REF: Draft Environmental Impact Statement (DEIS) RXR/Glen Isle Glen Cove Creek Mixed-Use Waterfront Development

As requested by the City of Glen Cove Planning Board, and pursuant to SEQRA regulations, Cameron Engineering & Associates, LLP has performed a detailed technical review of the above-referenced *Preliminary Draft Environmental Impact Statement* ("PDEIS") sections related to Traffic, Air Quality, Noise, Civil Engineering/Site Planning, Ecology, and Water Resources.

TO:	Glen Cove Planning Board
FROM:	HR&A
DATE:	7/20/2009
RE:	Review Comments on DEIS
cc:	Michael Zarin, Zarin & Steinmetz Brad Schwartz, Zarin & Steinmetz

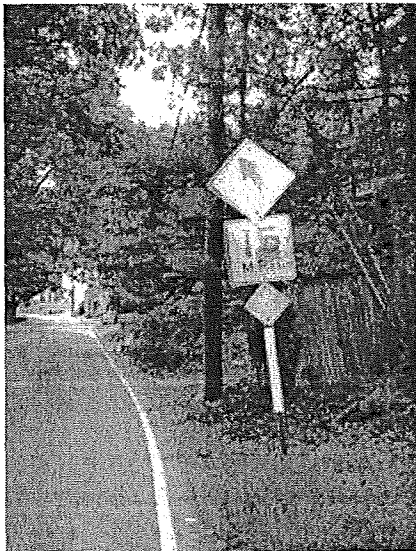
Equally significant and of serious concern is that the DEIS while identifying intersections along Prospect/Albin it fails to provide a proper analysis of the inadequate ***Stopping and Intersection "Sight Distance"*** at these various intersections. The geometric conditions, hill's, steep curves, change in area roadway width, blind turns, narrow steep secondary streets and lack of pedestrian right of way along Prospect/Albin do not meet even the minimum Sight Distance requirements as defined in the AASHTO *"Policy on Geometric Design of Highways and Streets"*. As evident below.

Property Damage Prospect Avenue

Lack of Drainage/ Excessive Run-off Albin Street

No pedestrian facilities blind turns

Downed STOP SIGN/HIT & RUN
